Louisiana Department of Transportation and Development Change Order Report		NO.	001
		Date:	05/07/2025
S.P. NO.	H.013429.6	F.A.P. NO.	H013429
Name:	DOWNTOWN THIBODAUx SIDEWALKS	Primary Parish:	Lafourche
		Category 3 / 7C	
This change order requires an LADOTD authorizer

EXPLANATION & JUSTIFICATION: The purpose of this change order is to incorporate 3 revised plan sheets and adjust some related item quantities.

State Project No. H.013429.6

Plan Change #001

SHEET NUMBER		49	
DESIGNED		LAFORCHE	
CHECKED		000-29	
DETAILED		H.013429	
REVISION OR CHANGE ORDER DESCRIPTION		67 of 83	
NO.		DATE	
1		07/25/24	
2		10/21/24	
AH		RMR	
BY		BY	
STATE OF LOUISIANA		DOWNTOWN THIBODAUX SIDEWALKS	
BENTON ASSOCIATES		GEOMETRIC DETAILS

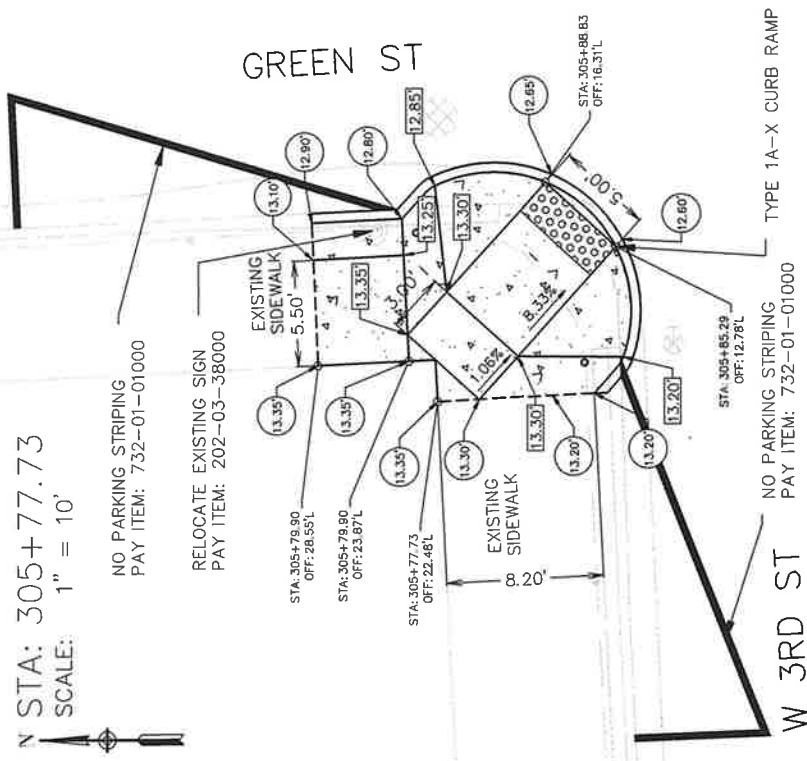
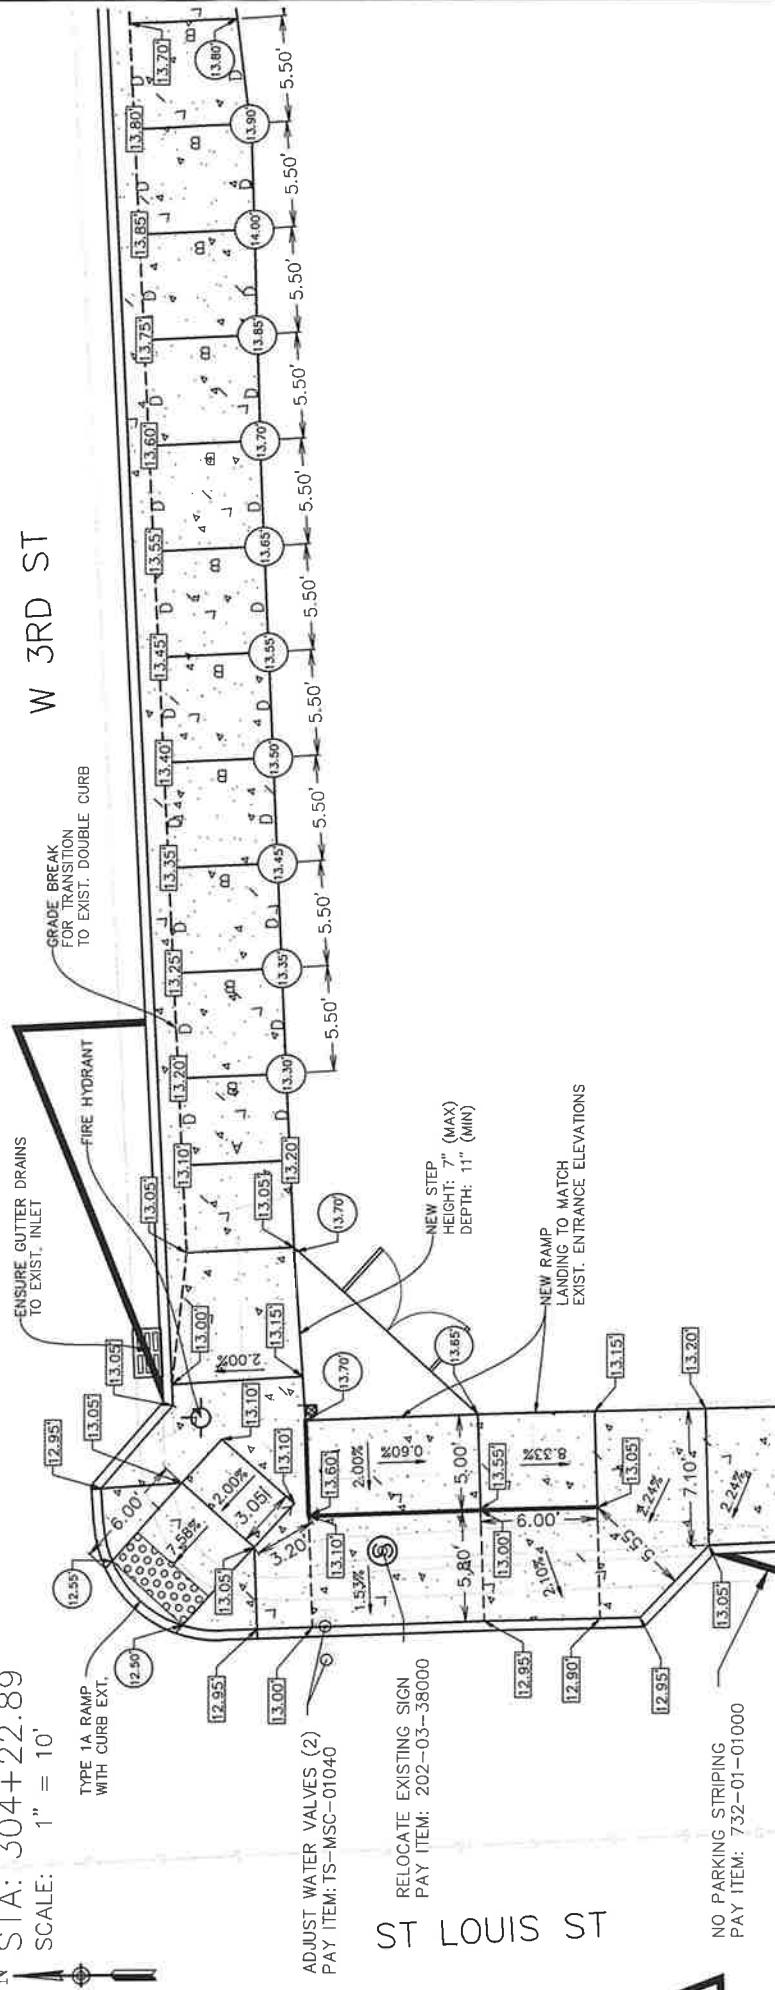
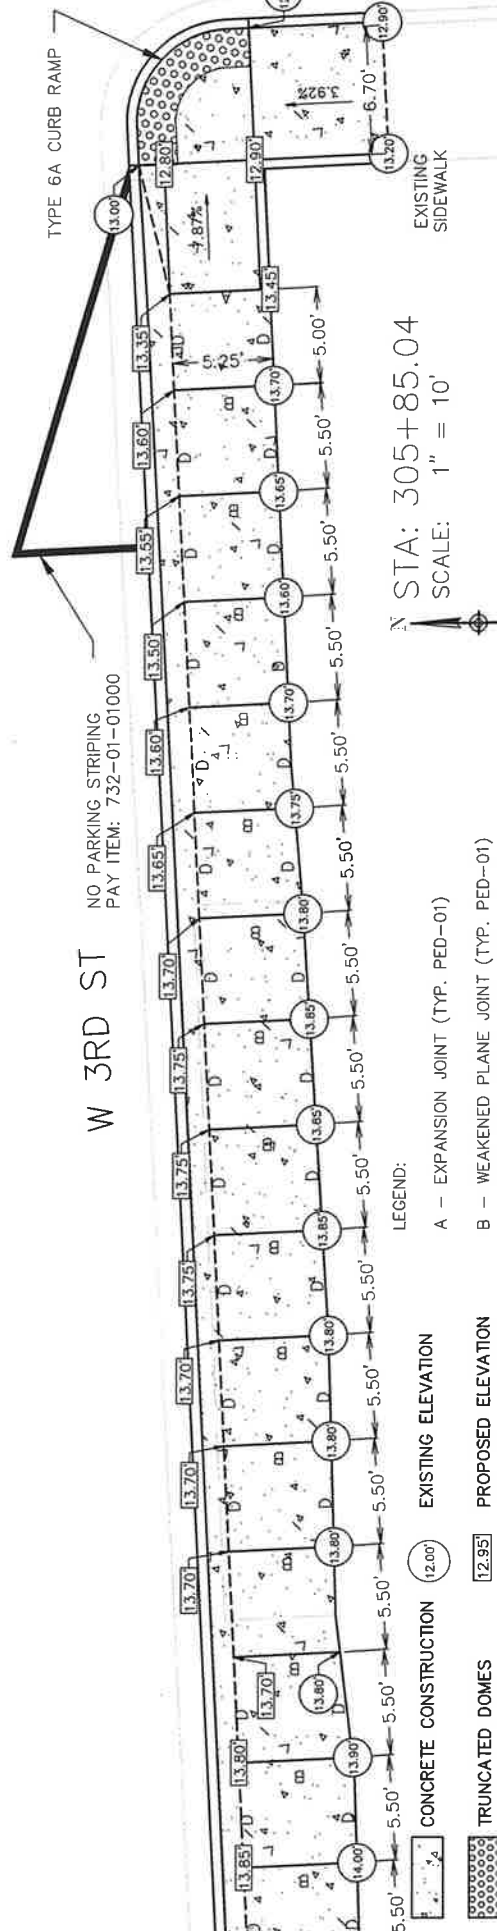
Original Sheet 15 only showed installation of a retrofit detectable warning surface on the existing concrete on the NE and SE corners of West 3rd St and St Louis St. The existing slopes were in excess of 15% and noncompliant with ADA standards. These street corners were redesigned with new Type 1A curb ramps and additional sidewalk concrete to correct these slopes.

Revised Sheet 49 quantity increased by 20.9sy on the SE corner of West 3rd St and St Louis St.

Revised Sheet 49 quantity increased by 20.9sy on the SE corner of West 3rd St and St Louis St.

Revised Sheet 49 quantity increased by 13.4sy on the SE corner of West 3rd St and St Louis St.

Revised Sheet 49 quantity decreased by 1 each on the SE corner of West 3rd St and St Louis St.
